CONTRACT CHANGE ORDER NO. _____
SHEET ____ OF ____

SAN FRANCISCO OAKLAND BAY BRIDGE
EAST SPAN SEISMIC SAFETY PROJECT

OAKLAND APPROACH STRUCTURES CLEANUP ITEMS

HANDRAIL ADJUSTABILITY DETAILS

TYPICAL EXISTING POST BASEPLATE

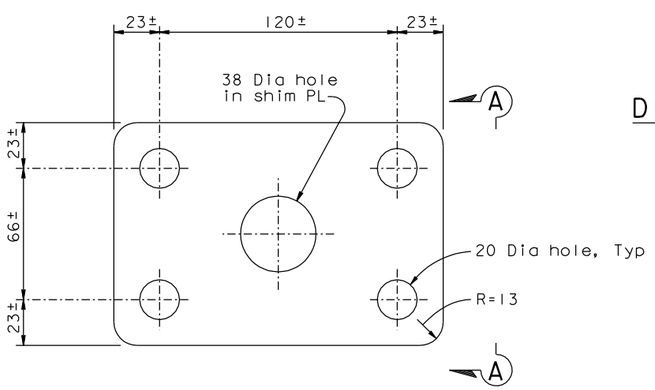
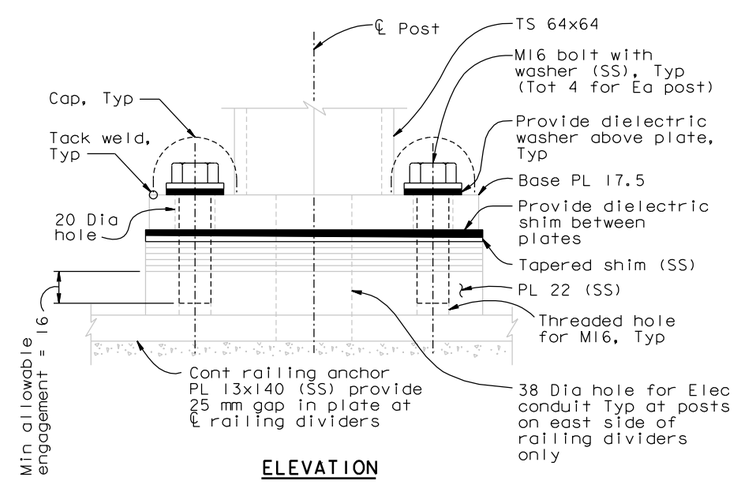
BOLT AND SHIM REPLACEMENT PROCEDURE:

1. Remove and discard M16 bolt (SS), cap (SS) and washer (SS).
2. Remove and discard the dielectric material above and below the base plate.
3. Clean out and dry the 16 mm threaded hole.
4. If needed, replace the top most existing stainless steel standard shim with a new stainless steel tapered shim of thickness and taper necessary to properly align top rail of bikepath railing.
5. Install dielectric shim (UHMW) below base plate.
6. Install dielectric washer (UHMW) above base plate.
7. Insert new M16 bolt (SS), domed cap (Galv) and washer (SS). The length of the bolt shall be such that the engagement length into the PL 22 is a minimum of 16 mm.
8. Bolts shall be tightened to "Snug Tight Plus ¼ Turn". Bolts shall be installed with thread locking compound.
